## **Consultation Report**

### **Fairwater & Llandaff: Llantrisant Road (Plas Dwr) – Road Hump Regulations**

**Project No:** SPHTT15397

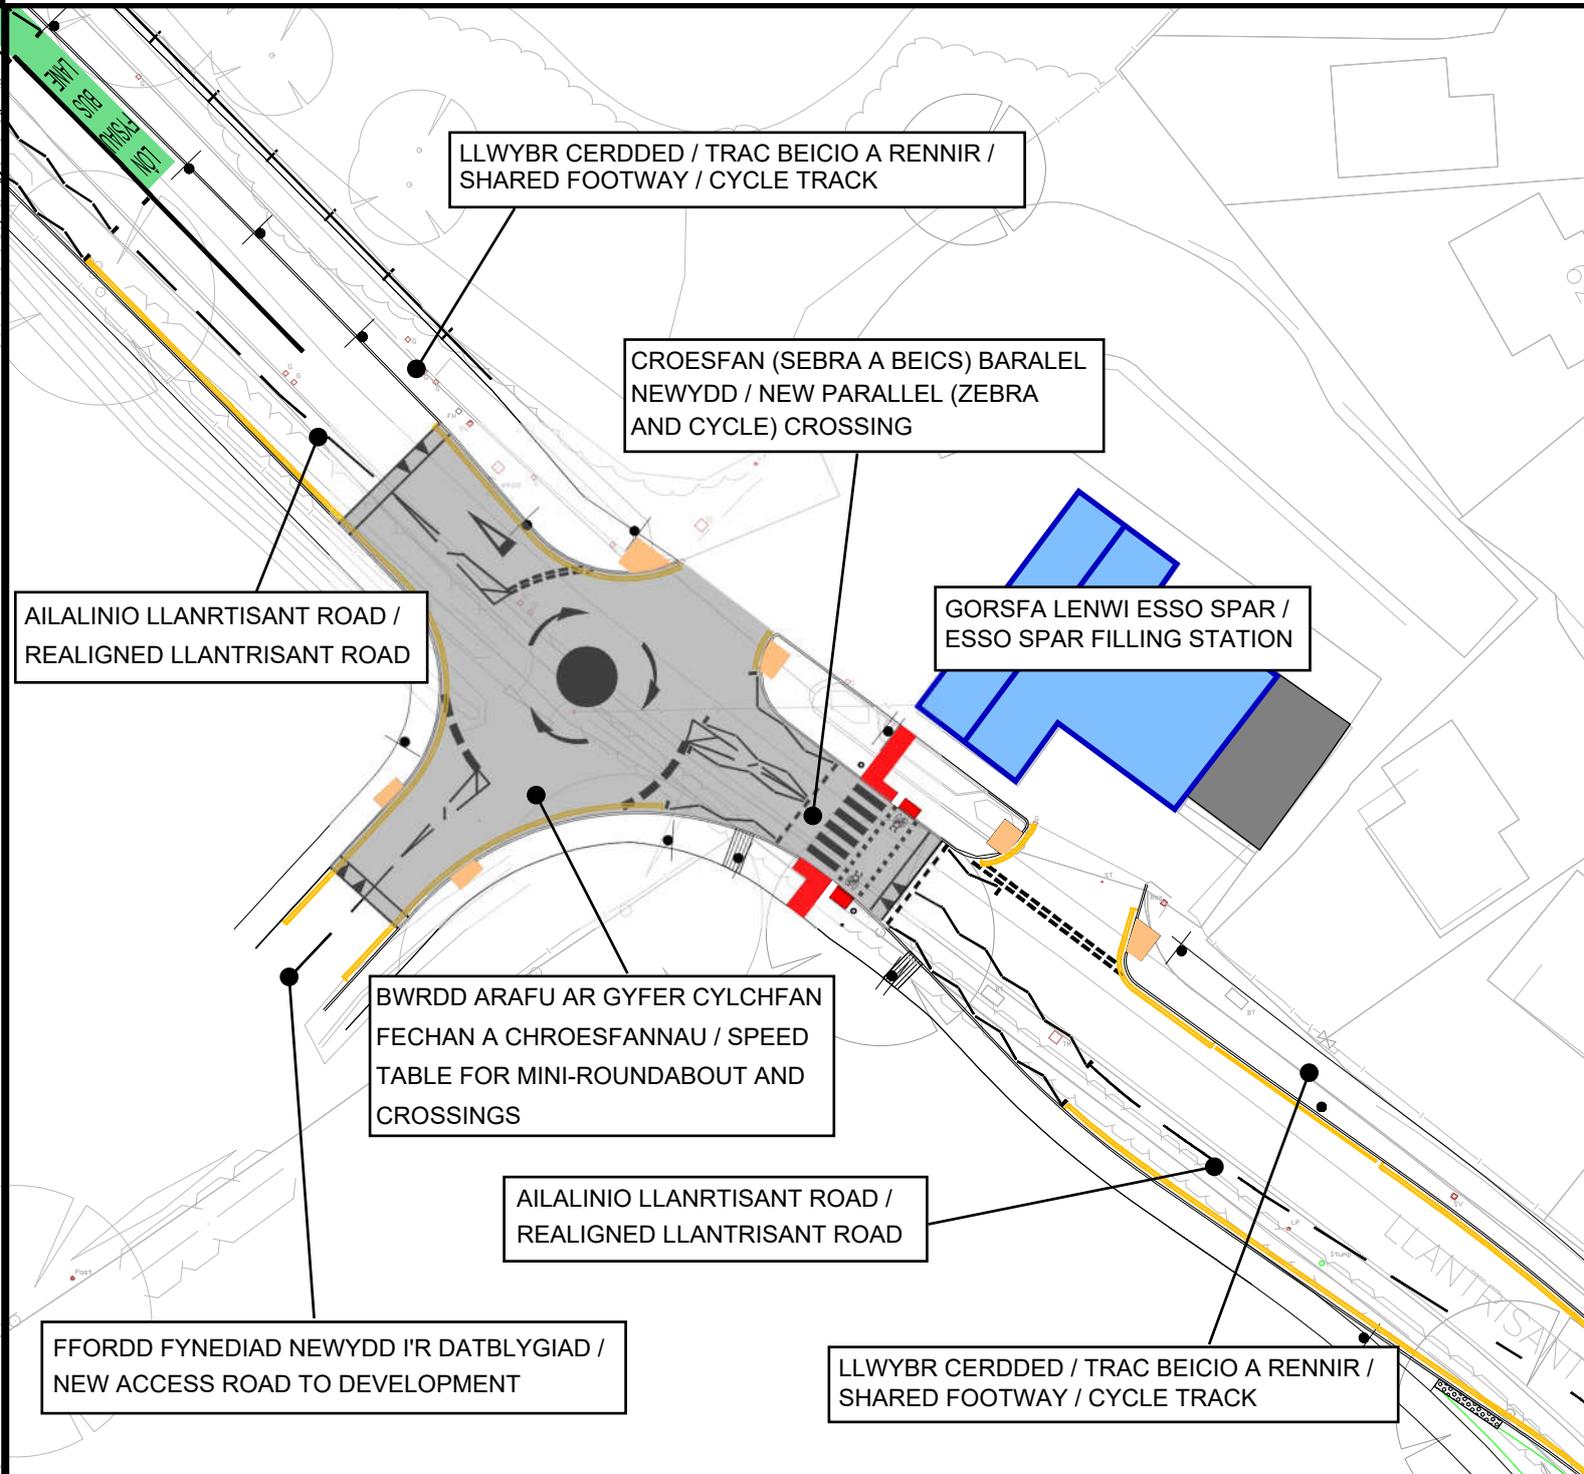
*Wherever full width speed tables are introduced we always express concern around their profile of them and the ongoing maintenance. Across the city there are many examples where the profiles vary to such a degree that they compromise both our vehicles and quality of ride experience.*

*The ongoing operation over these restrictions hasten the deterioration of components on the bus and thus incur a higher replacement rate and cost of our operation. They also have a detrimental impact on the ride quality, and this can have a negative impact on the number of journeys customers undertake. We note the distance between the proposed the two speed tables is close in the proposal.*

*“I note this doesn’t seem to include priority side road crossings for the shared use foot/cycleway over the entry and exit to the garage. Current best practice under ATA would suggest that ought to be considered. Also, how does this link into the AT infrastructure being provided through the development linked into the roundabout?”*

*“Cycle network route, meaning that it has to meet the standards set out in the Active Travel Act.*

*The proposals show a shared use footway / cycle track, with no further details. Please revise the proposal to show compliance with Active Travel Act Design Guidance DE024, Cycle Track Alongside Road, Shared with Pedestrians. Note that the margin strip should be a minimum 0.5m wide as the road speed limit is 30mph.*

*The proposals show the cycle track seemingly giving way at the two entrances to the petrol station. DE024 states that 'shared cycle tracks should be continuous across private accesses. DE025 shows how to treat give the cycle track priority at side roads.*

*Please revise the proposal to show the cycle track having priority as required.”*

It is acknowledged that there are speed ramps with different gradients across the City and we will try to provide a consistent ramp gradient on all new ramps. In order to provide a comfortable ride for bus passengers, these ramps will be designed with a gradient of 1 in 16, with a distance of over 40 metres between the on and off ramps, which should not cause damage to vehicles if driven over at a suitable speed.

Regrettably, one of the only methods we have available to slow traffic down is the use of speed tables. Speed tables are suitable for this location in order to create a safer highway environment around this proposed mini-roundabout.

Furthermore, there is only one large speed table for both the crossing and the roundabout and so there is not an issue of proximity of speed tables. In addition, the location and height of the mini-roundabout dome has been designed to enable buses to pass through the junction without their wheels running over it.

Regarding the responses in relation to the shared footway and cycle track, we would firstly comment that the design of the footway and cycle track are not the subject of the consultation but the views are noted and we would respond as follows.

Firstly, this scheme is part of the outcome of a planning application that predates the Active Travel Act Design Guidance and so the scope to vary the design is limited by that process.

The entry and exit from the garage are being treated as side roads and not private accesses, due both to the nature of the public access to the facility and the types of vehicle that will use it.

The recommendations of DE024 for a 0.5 metre verge are noted, but not considered to be beneficial in this case. The layout of DE025 would require private land and so cannot be considered.

The exact routing of cycle tracks within the site are not yet known, but it is anticipated that they will access the locations of the two Toucan crossings rather than the mini-roundabout.
